工程指示 / 要求簡箋(E.I.)

工程指示編號：EI / 9100 / 25 修改版次： A
 工程編號： J - 858 工程名稱：將軍澳日出康城
 工程項目：幕牆 第 9 次 補玻璃 62 件 (小業主單)
 收件人：Maggie 發件人：Jason 日期：28/08/2025

PROJECT: 康城11期凱柏峰

項目: 鋁窗, 鋁門及幕牆玻璃的驗收表格

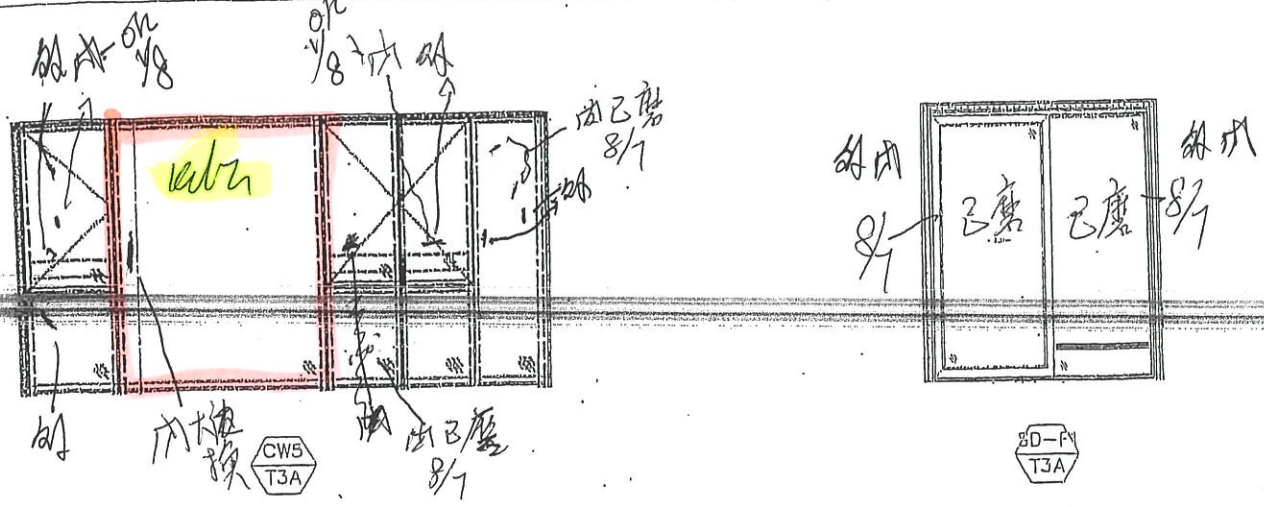
8-8 705 曬室內OK

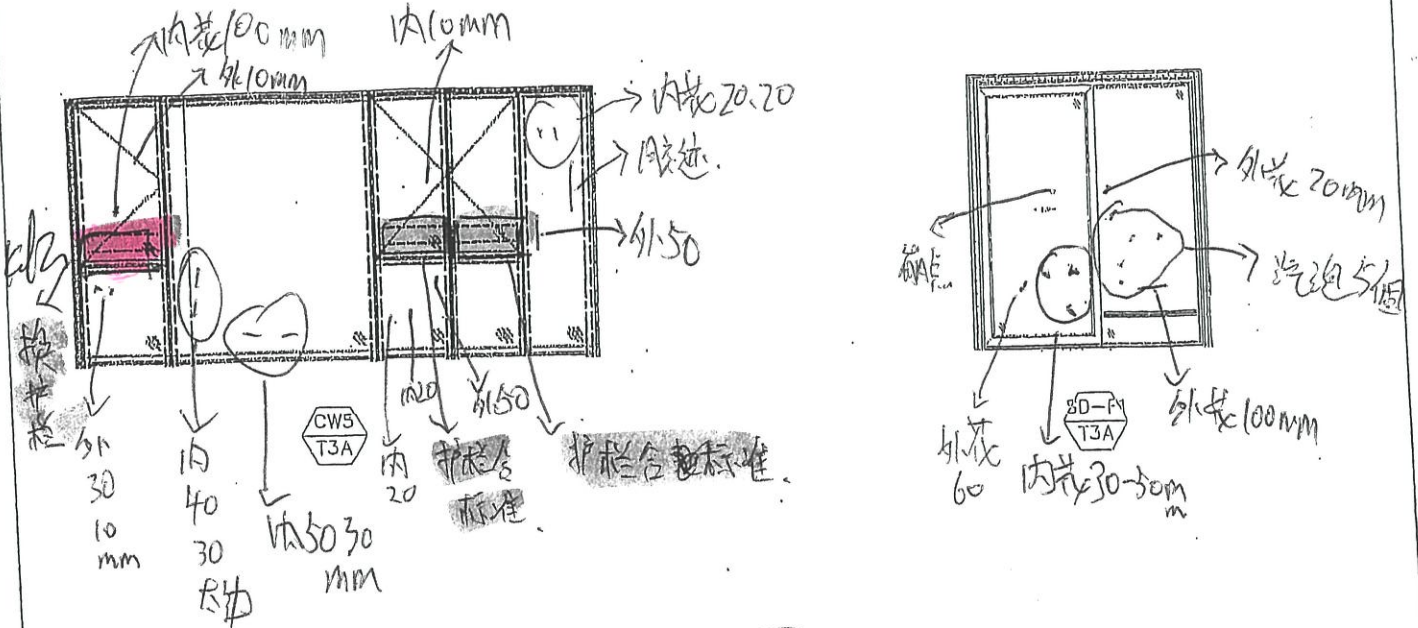
8-7-2025 已磨 OK
內花已磨 ✓
幕牆外花待吊板

外 OK 825

TOWER: 3A 樓層: 9-67 39/F 單位: B

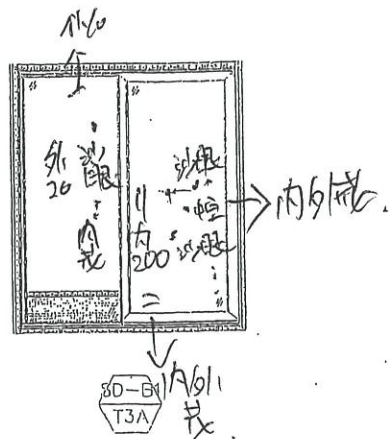
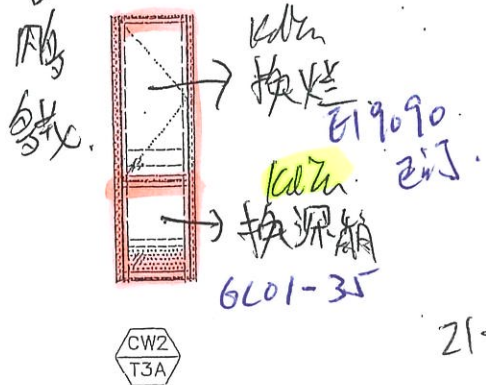
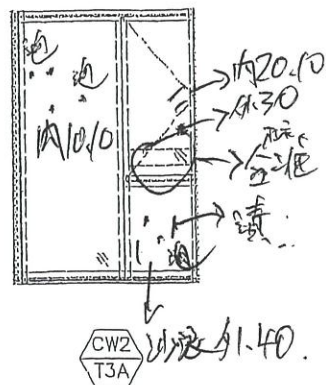
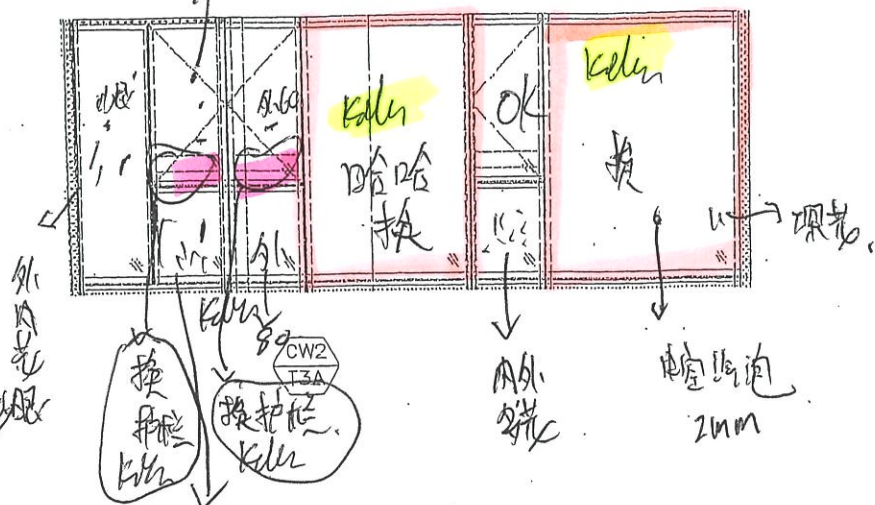
框箱
幕牆抗拉手, 換色, 膠條松脫
窗扇抗窗
超11換色, 換門

!!! 死牆面开窗
換色框箱

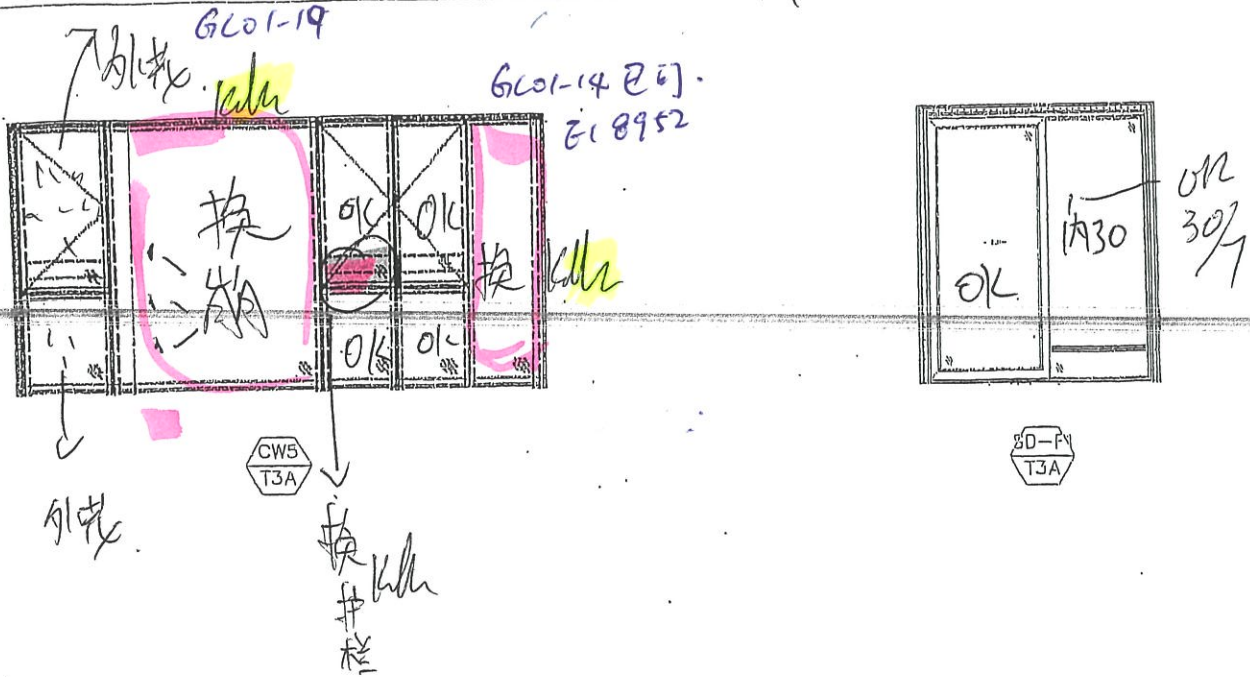
起內封玻璃膠. 封色: 內外.

幕牆封色補膠. 防水膠及松

TOWER: 3B. 樓層: 9-67 35/F BE 單位: E 0/

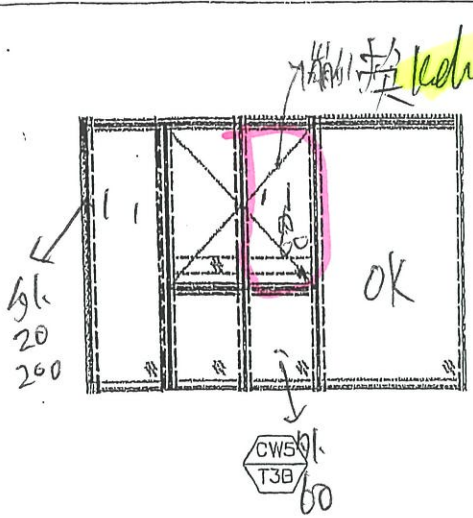
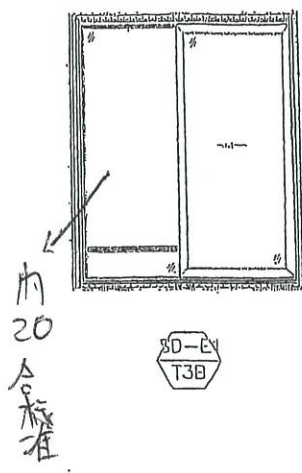
趙門執色

趙門執色. 拉手緊. 內外執色.
幕牆執色. 拉手緊

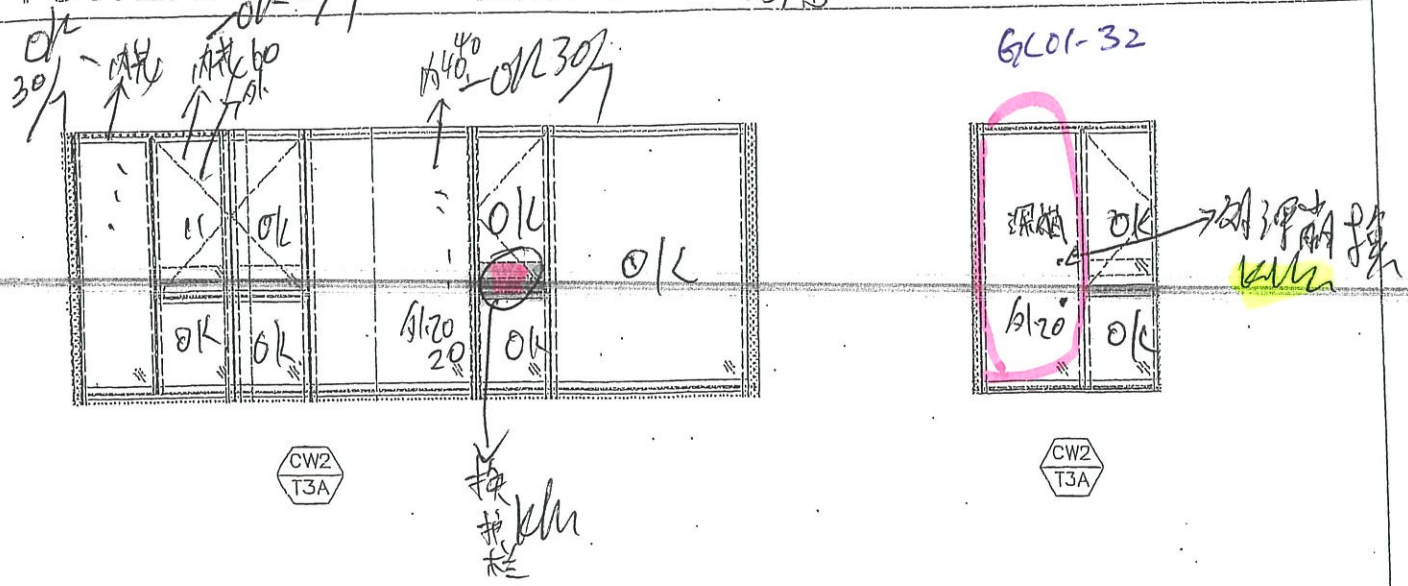
窗門顏色內外膠條短
幕牆顏色內外膠條

TOWER: 3B 樓層: 9-67 30BE 單位: E

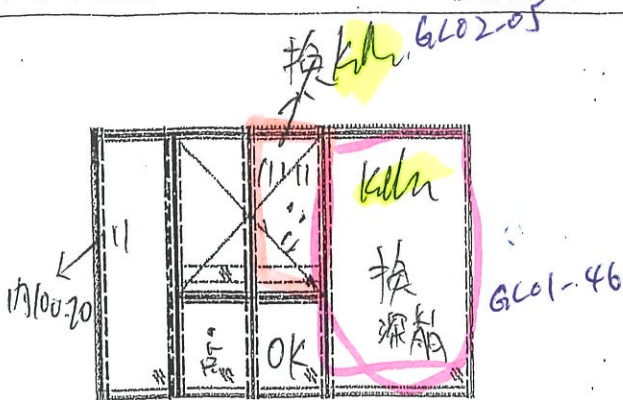
趙門外崩 拔色.

补胶.

硅胶边松.

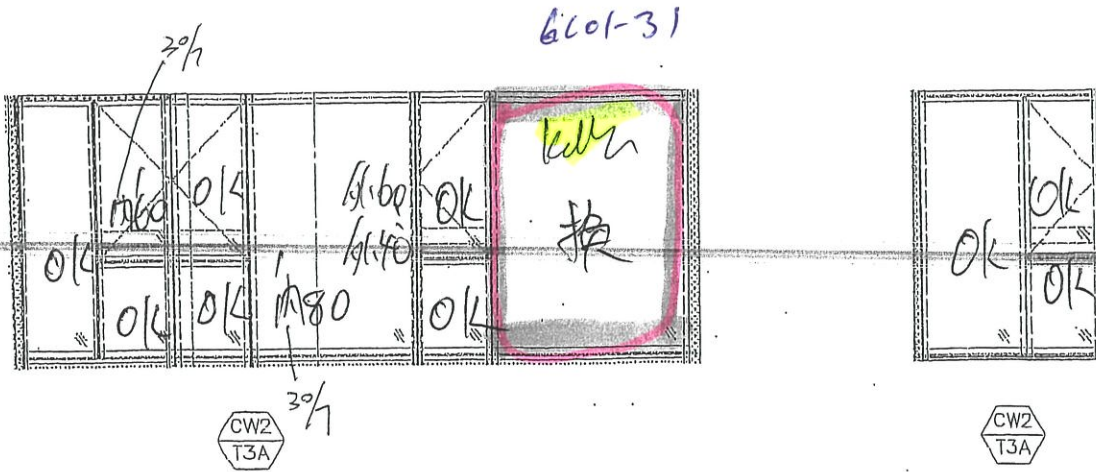
趟門外執膠玻璃

趟門漏風 執色

幕牆執色 執窗, 膠條長

窗扇執膠

TOWER: 3B 樓層: 9-67 28/F BD 單位: D 01

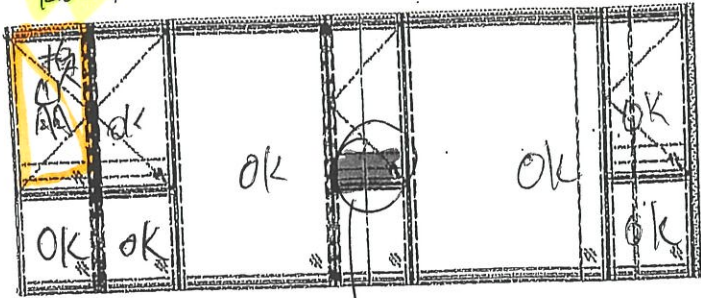
換把位

內外
趟門漏風, 執色, 執膠
幕牆執色執窗,
廁所窗執窗補膠,
廚房窗執色.

樓層: 9-67 28/F AA 單位: A

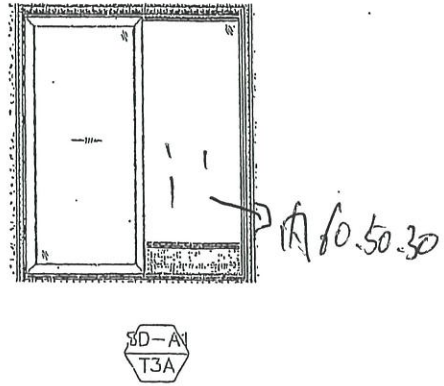
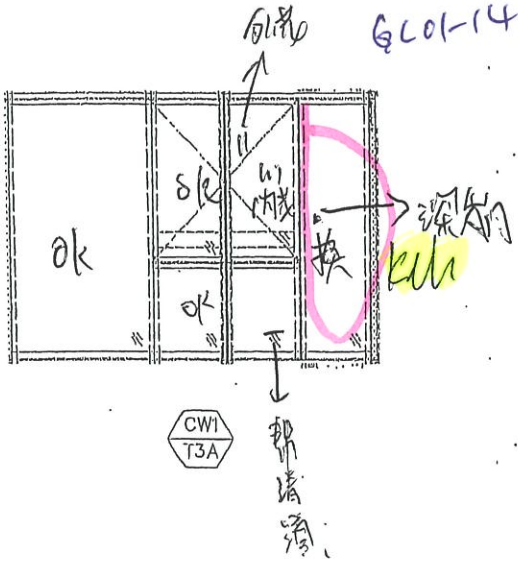
超批色. 內外. 門頂

幕牆補裝. 批色框凹

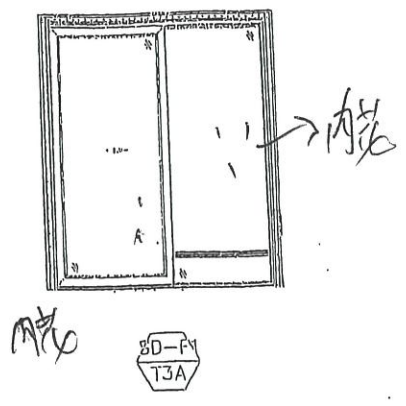
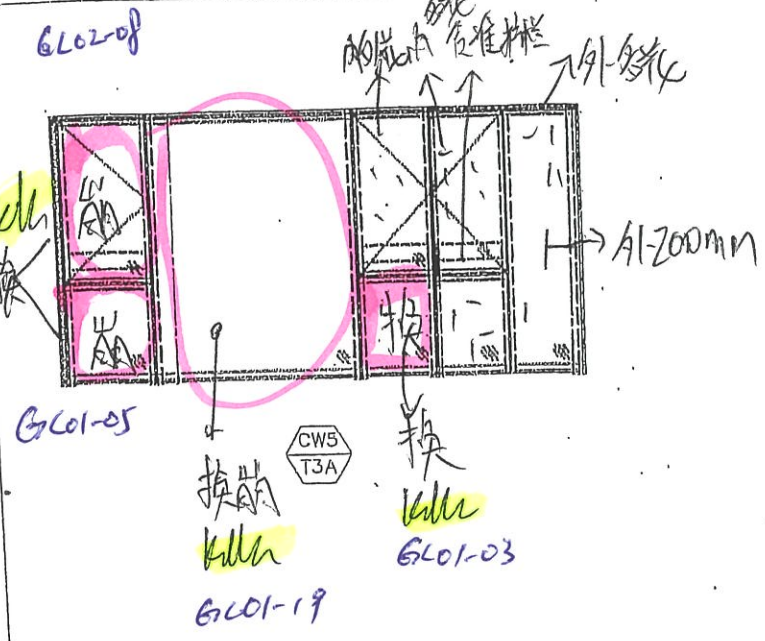
換色封窗

趟門外換色

樓層: 9-67 22/F BF單位: F

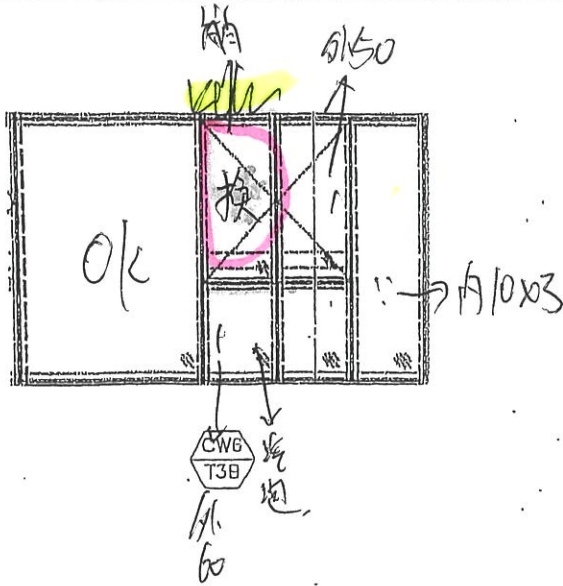
鋁門 拆色: 鋁門漏風

幕牆 拆色: 拆色漏風 封窗

TOWER: 3A 樓層: 9-67 21/F AB 單位: B

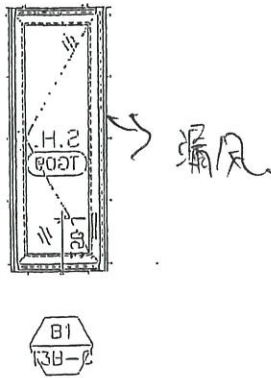
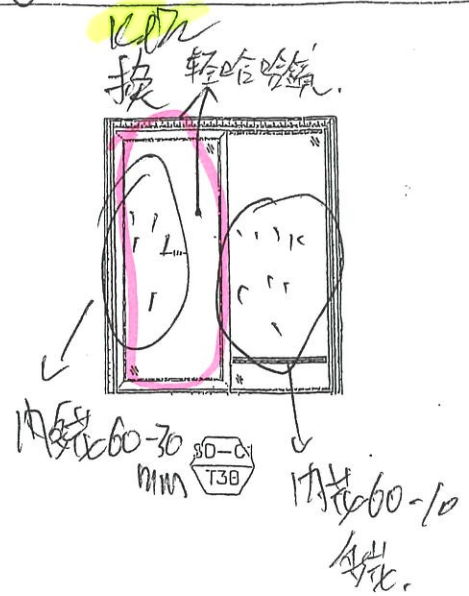
批收幕牆 廚房窗批色, 批收。
批窗有聲
批色。

TOWER: 3B 樓層: 9-67 20BC 單位: C

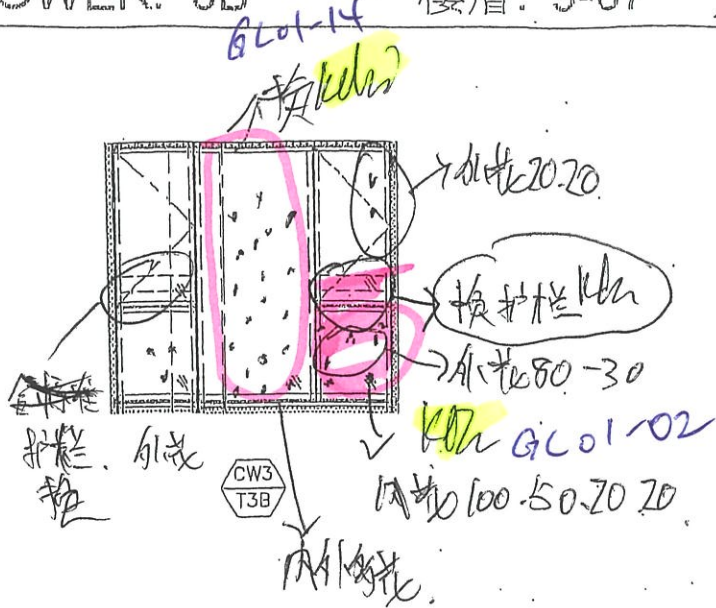
抽色到房
抽窗不順
膠條松脫
趟門開關不順

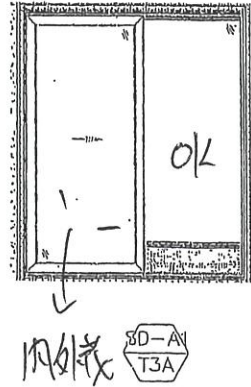
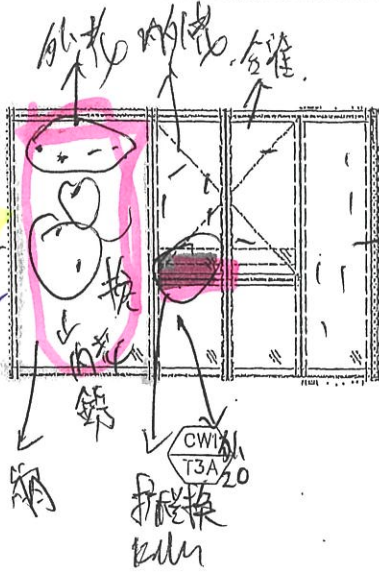
越心補膠, 灰色膠緊, 拆去子L

幕牆窗漏風, 膠抽長

樓層: 9-67 20/F AB 單位: B

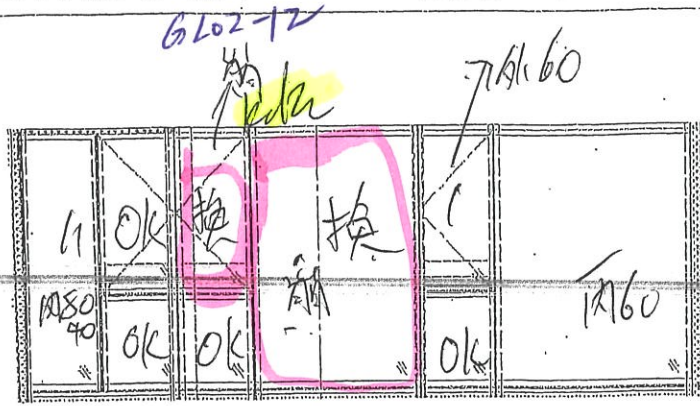
趟門執色.
幕牆執色.
執膠. 高2 清膠.
窗窗 膠膠 漏風.

樓層: 9-67 19/F BF 單位: F 01-02

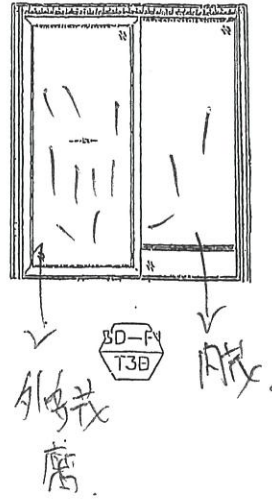
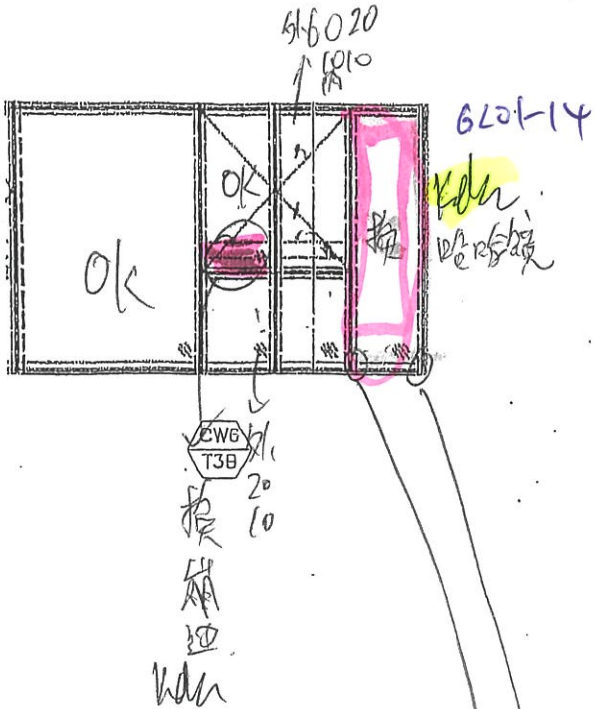
幕牆補膠

趙內外補膠

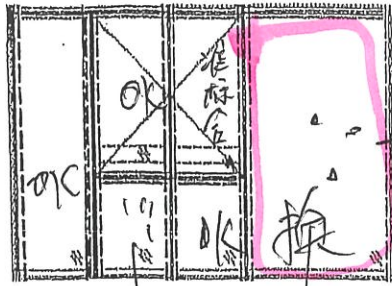
趟門膠差 秤 執色 外表

防水條松 幕牆 執色

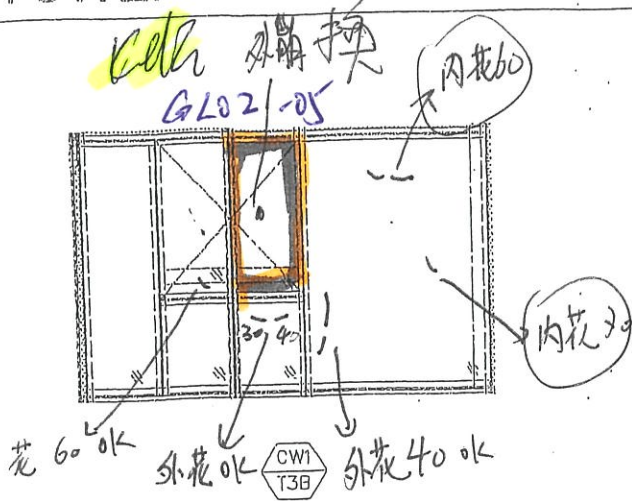
趨向不順

樓層: 9-67 ^{16/F} BD 單位: D 01

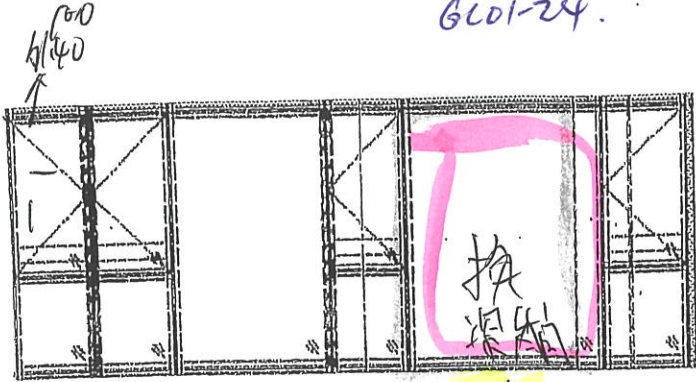
牆內內外執色, 收口起段, 月飾不平.

收口櫃執上^中櫃蓋及, 和膠

幕牆執色, 廁所窗執色, 廚房窗執色

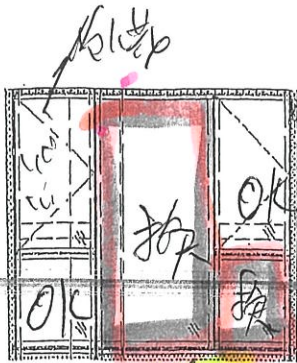
趟門批色. 內外. 換膠.

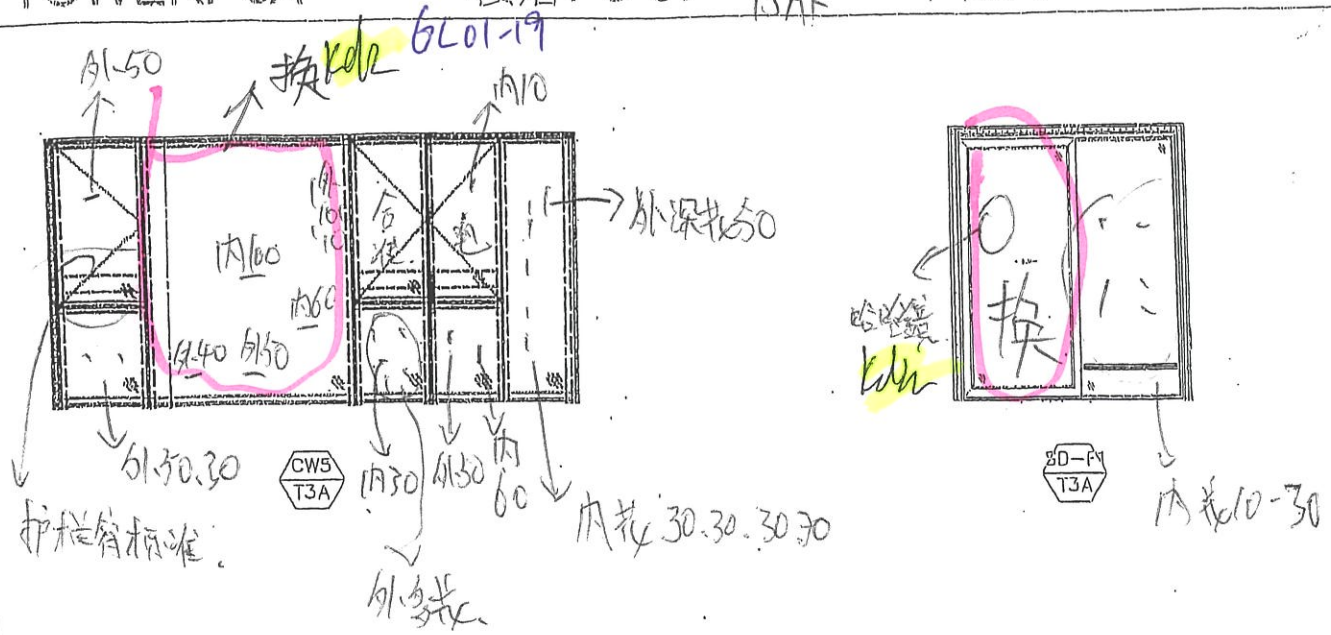
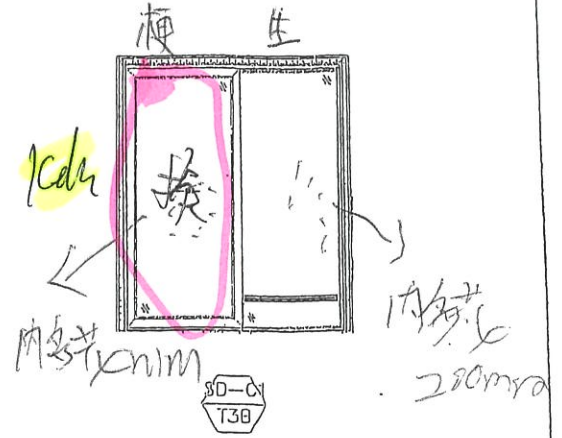
趨門漏風.

廁所窗開關不順. 膠有隙.

窗膠條長短問題.

批色

TOWER: 3B AC 樓層: 9-67 15AC 單位: C

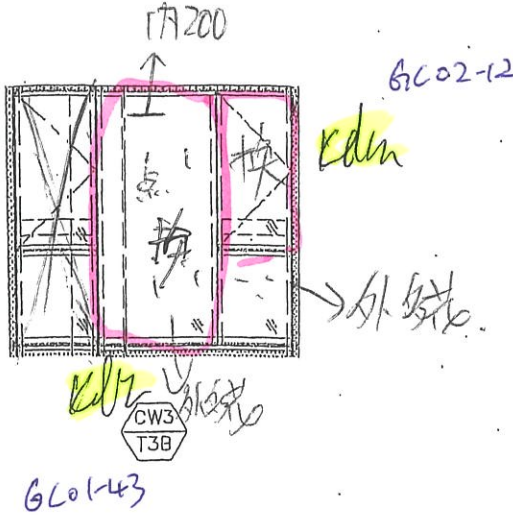
窗門刮玻璃清潔油迹. 膠迹.
抹色.
廁所玻璃窗抹色
